# Product Change Notification

**Change Notification #: 107430 - 00**

**Change Title: Intel® PRO/Wireless 3945ABG Network Connection Skus: WM3945AGJPGEN (MM# 874740), WM3945AGJPWB (MM# 878738), and WM3945AGBGXGEN (MM# 878806), PCN 107430-00, Label, Product Label change to update JP DSPR #**

**Date of Publication: April 02, 2007**

Example : Printing on label.

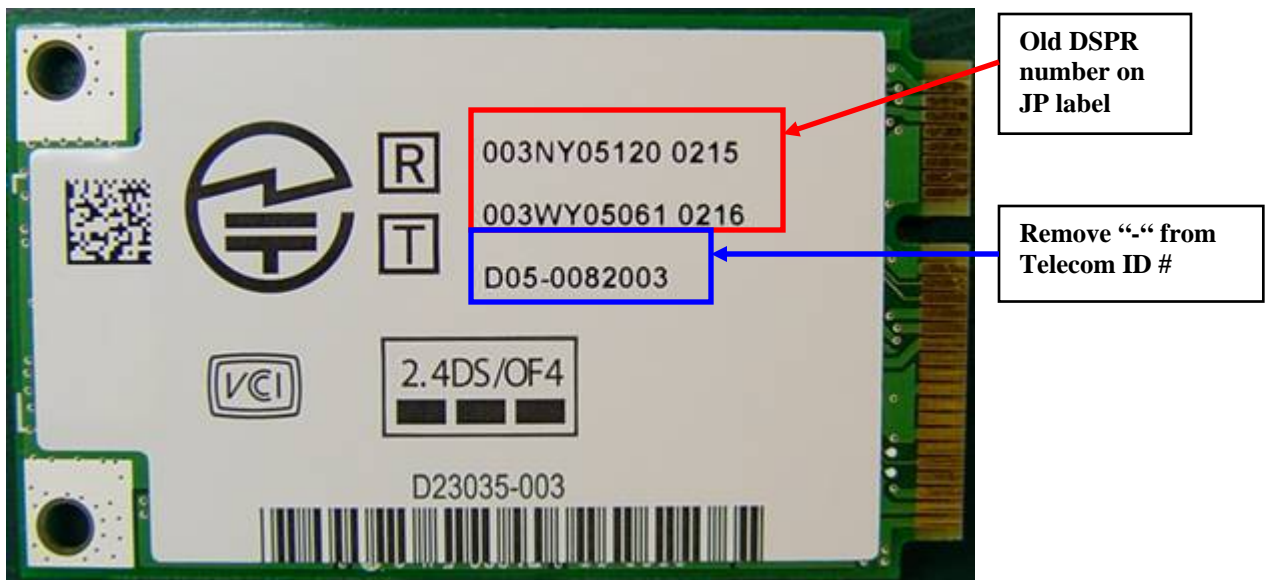
1. The new DSPR ID on the label

NEW DSPR ID#  
003NY05120 0216  
003WY05061 0217

2. The "-" from the Telecom ID number (the 3rd row of DSPR numbers) will be removed.

D05-0082003 changes to D050082003

3. Dash to the TA#
